From: WELLS Russell (AREVA) [Russell.Wells@areva.com]
Sent: Friday, July 29, 2011 5:28 PM
To: Tesfaye, Getachew
Cc: ROMINE Judy (AREVA); KOWALSKI David (AREVA); WILLIFORD Dennis (AREVA); BENNETT Kathy (AREVA); DELANO Karen (AREVA); RYAN Tom (AREVA)
Subject: Response to U.S. EPR Design Certification Application RAI No. 482 (5611), FSAR Ch. 9, Supplement 1
Attachments: RAI 482 Supplement 1 Response US EPR DC.pdf

Response to
Request for Additional Information No. 482(5611), Supplement 1

U.S. EPR Standard Design Certification
AREVA NP Inc.
Docket No. 52-020
SRP Section: 09.05.01 - Fire Protection Program
Application Section: 9.5.1

RAI 482,
Q 09.05.01-83

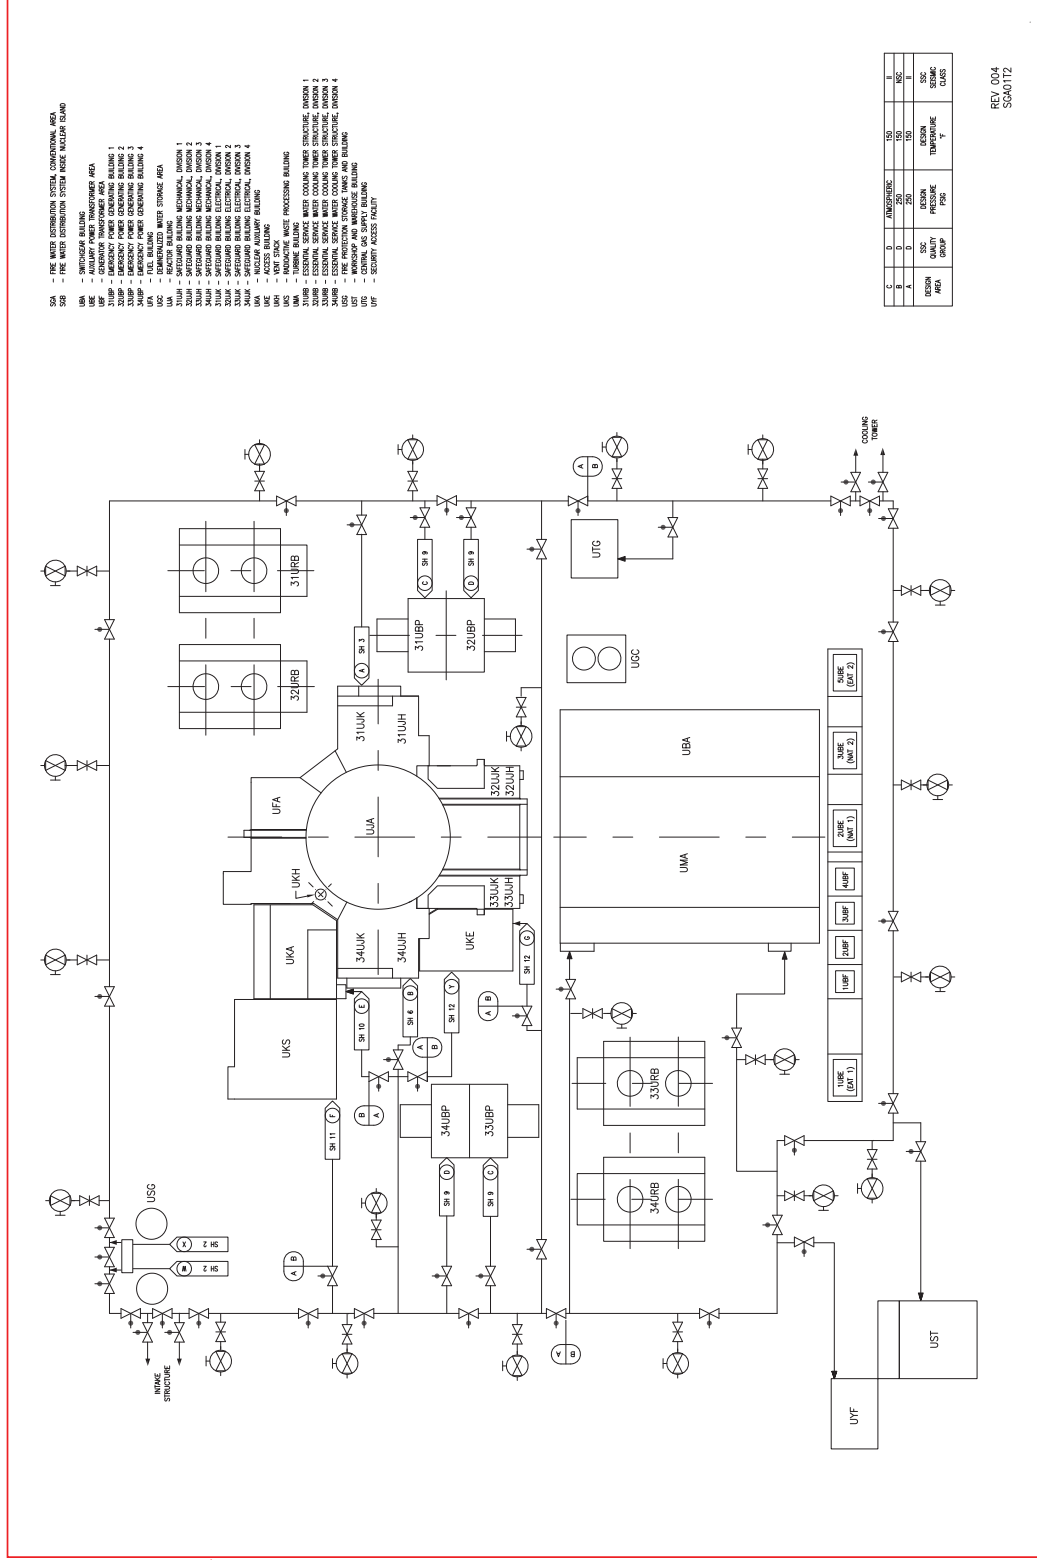
U.S. EPR FSAR Revision 2 Section 9.5.1.2.1 Subsection Manual Fire Suppression Systems states that "In the inner Reactor Containment Building the inboard and outboard containment isolation, motor-operated control valves are normally kept closed and are only opened during a fire emergency requiring the use of the standpipe system in the Reactor Containment Building." RG 1.189 Regulatory Position 3.5.1.3 states that the prefire plans should include fire brigade actions such as operating instructions for use of the fire suppression systems and references NFPA 1620 which states that the pre-incident plan for all standpipe systems should include location and identification of control valves. Due to fire effects inside Containment the inboard valve may not be operable and MCR indication may not be available and the fire brigade may need to manually operate this valve. Applicant needs to ensure the inboard valve can be manually operated and that the prefire plans include this fire brigade action.

U.S. EPR FSAR Tier 2, Section 9.5.1.2.1 will be revised to include the following statement:

"The inboard control valve can be manually operated. Prefire plans include this action for the fire brigade should automatic operation of the valve be rendered inoperable due to fire effects inside the Containment."

Figure 9.5.1-1—Fire Water Distribution System
Sheet 1 of 13

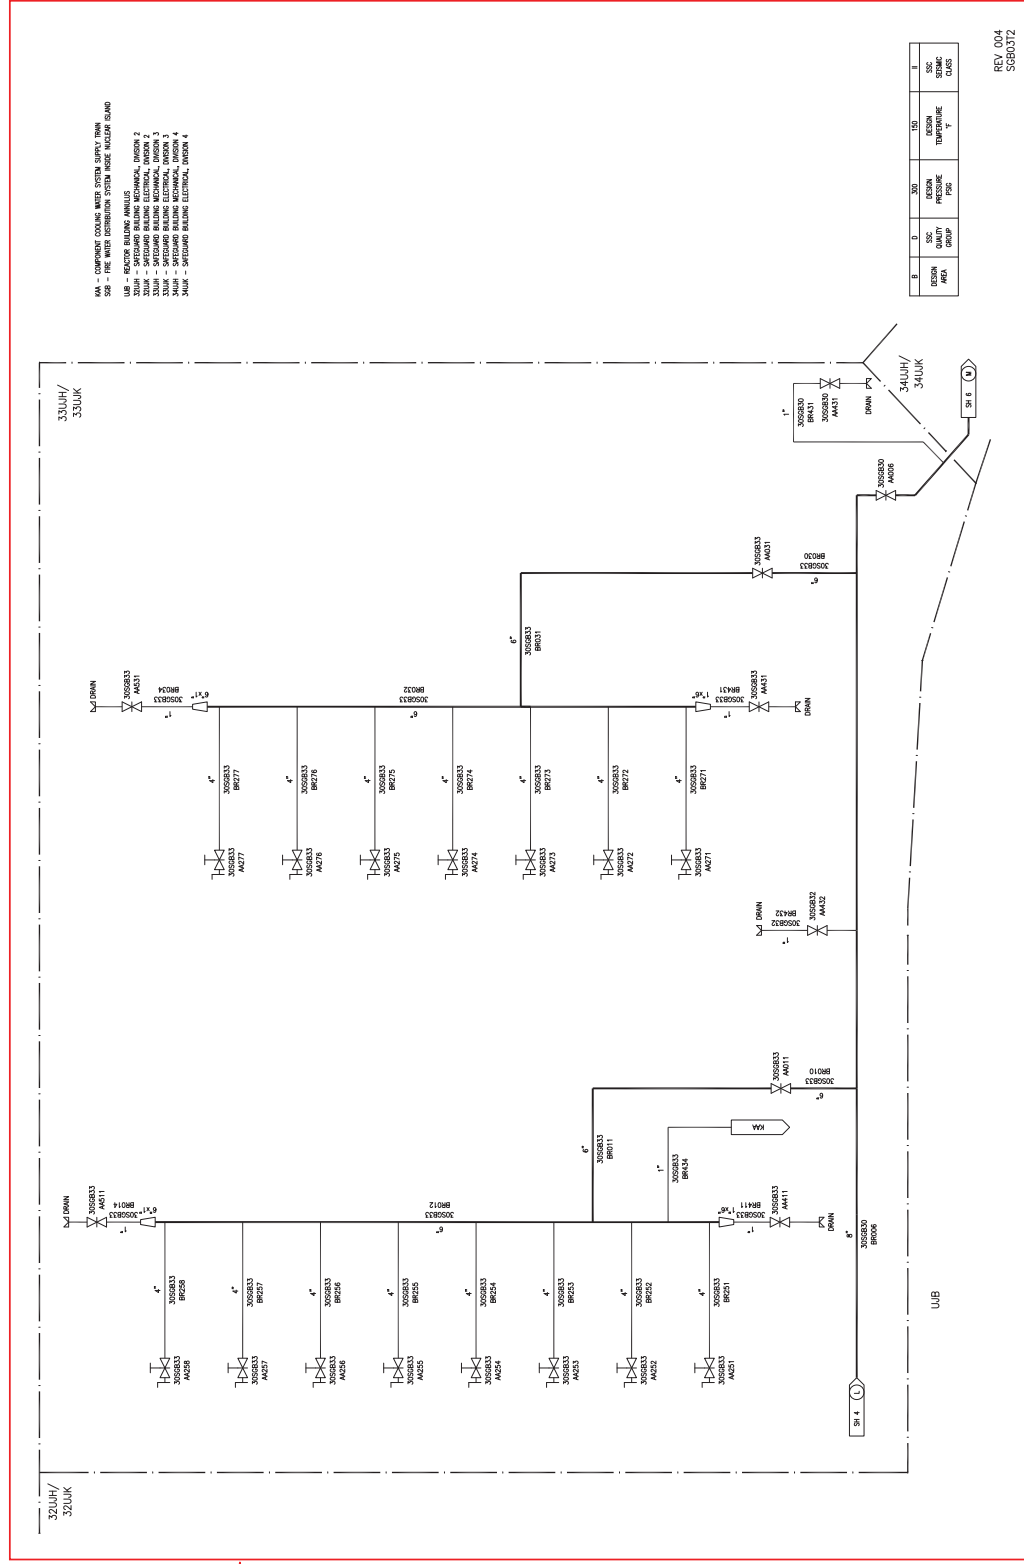
U.S. EPR FSAR Revision 2 Figure 9.5.1-1, Fire Water Distribution System, Sheets 4, 7, 8, and 13 have drawing errors. Sheet 4 shows that point "T" connects to Sheet 11 but it should connect to sheet 13. Sheet 7 shows that point "P" connects to Sheet 11 but it should connect to sheet 13 and that point "R" connects to Sheet 6 but it should connect to Sheet 8. Sheet 8 shows that point "R" connects to Sheet 5 but it should connect to Sheet 7. Sheet 13 shows that point "T" connects to Sheet 2 but it should connect to sheet 4 and that point "P" connects to Sheet 5 but it should connect to sheet 7. The applicant needs to revise Figure 9.5.1-1 as per above and review Figure 9.5.1-1 for any other discrepancies and revise as needed.

U.S. EPR FSAR Tier 2, Figure 9.5.1-1—Fire Water Distribution System, Sheets 1 through 13, have been reviewed for discrepancies. Sheets 1, 3, and 4 through 13 of this figure will be revised to remove existing discrepancies from fire water distribution system drawings.

RAI 482
Q. 09.05.01-82
